Re: Response to Design + Sustainability Advisory Panel Meeting Report

Address: 22 Forest Way Frenchs Forest NSW 2086

Application No: DA2023/1757

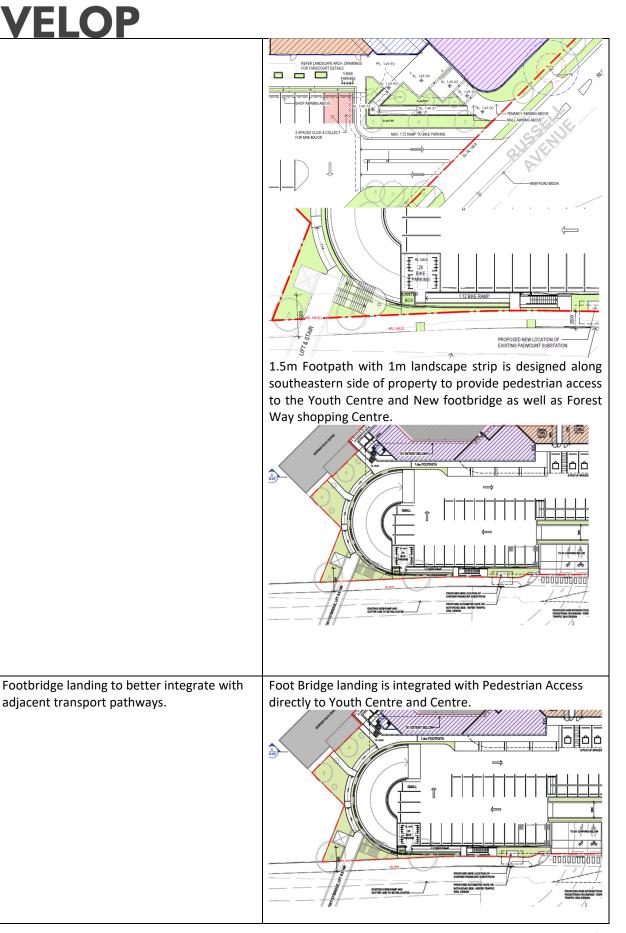
Promote alternative transport by provisioning for legible access and considering how structures and spaces may adapt to support greater numbers of people arriving on foot or by bike in years to come.

A 2.5m wide shared path is provided along Forest Way as per Frenchs Forest Active Transport Network.

Designated Bike Parking area with bike access ramp are provided for cyclist visiting the centre from both west bound and southeast bond.

This contributes to the separation of Bicycle and pedestrian access on Forest Way.

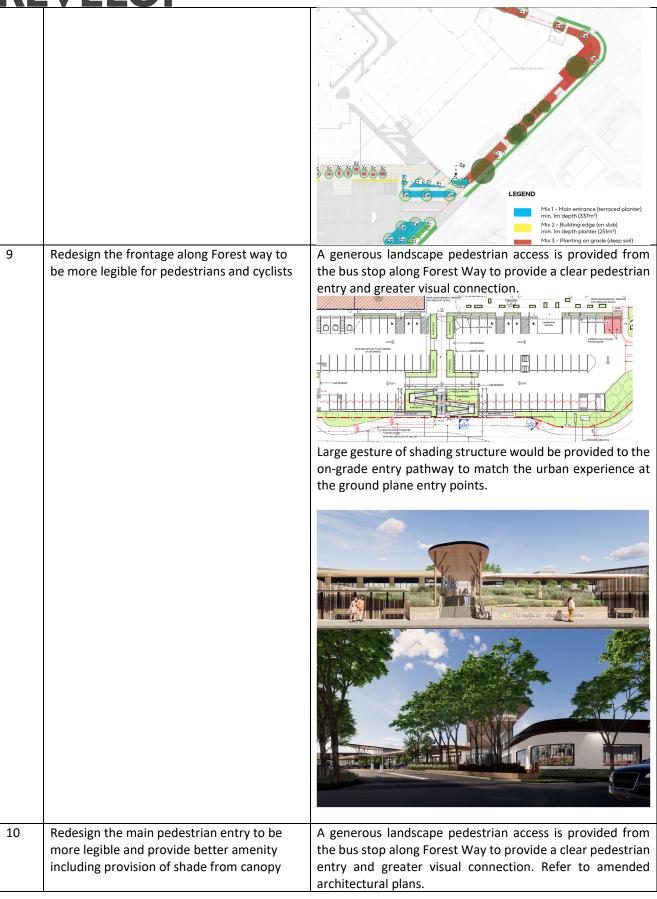
| Land | scape | |
|------|--|--|
| 8 | Provision of greater landscape setbacks to enable planting of both trees and screen shrubs. | Russel Ave setback is increased to 3m. Generous deep soil landscape planting is provided. |
